TWED HEIGHTS
KAMPALA

drawing description
Presidential Suite
Kitchen paneling and
sliding door - SHEET1

project number S-89-18	drawn by VC
drawing number THK-JN-8556A	scale A0 - See drawing
revision 0	date 2024.03.11
drawing approval Rev.-20**.**.**_IS

plan view scale 1 : 20

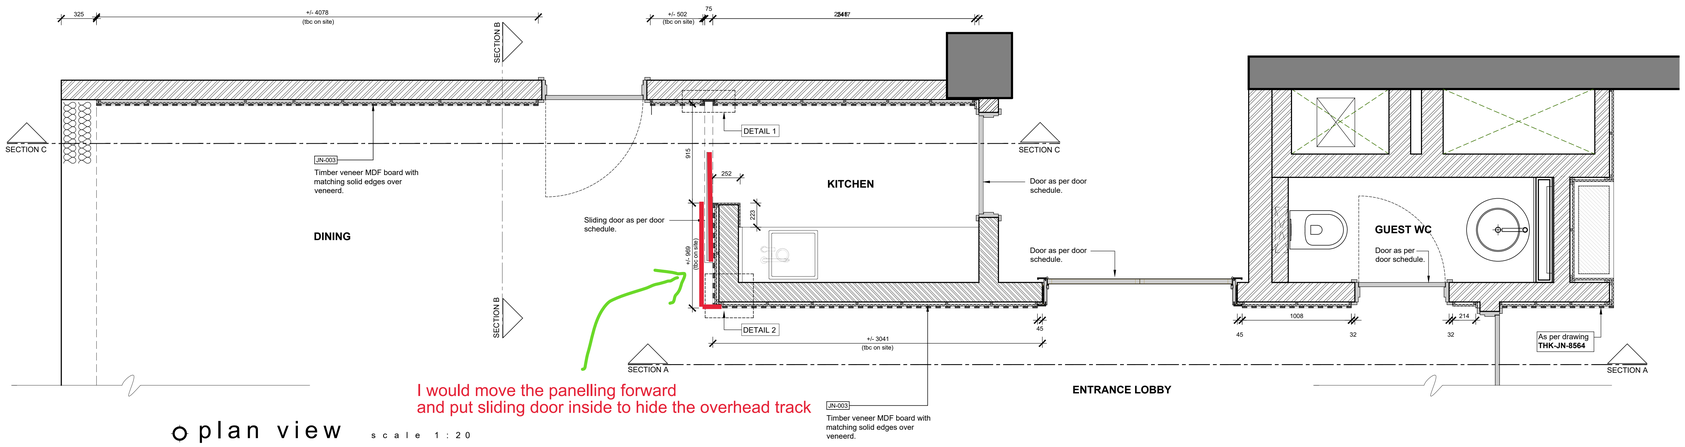
I would move the panelling forward
and put sliding door inside to hide the overhead track

Please add in sliding door part of this joinery - cannot be part of door schedule
as it needs to be same finish and detailing as panelling. The doors will be made by someone else

section B-B scale 1 : 10

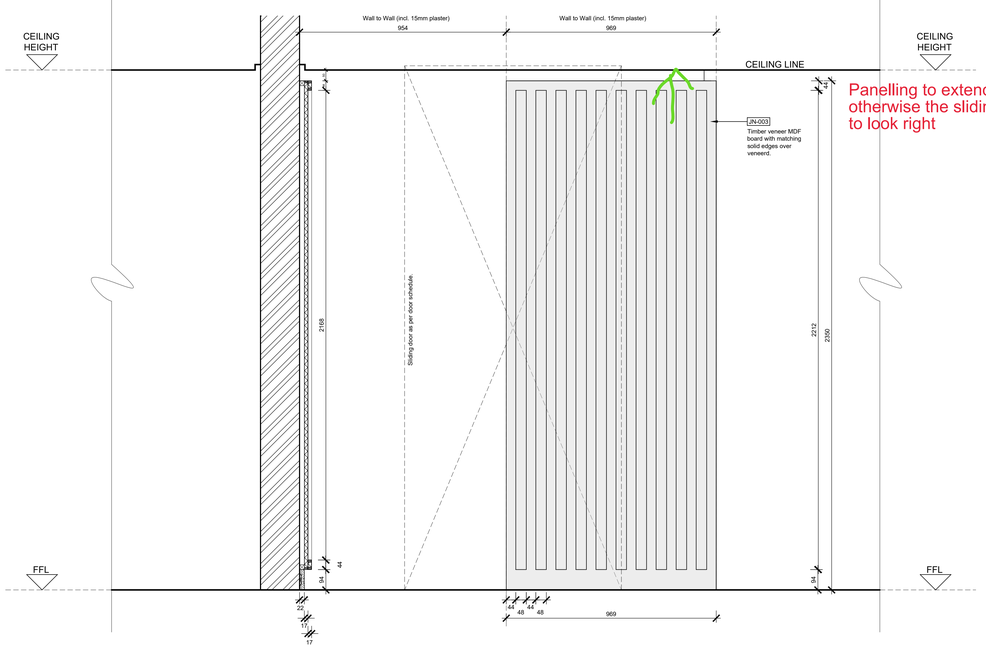
Panelling to extend to ceiling,
otherwise the sliding door is not going
to look right
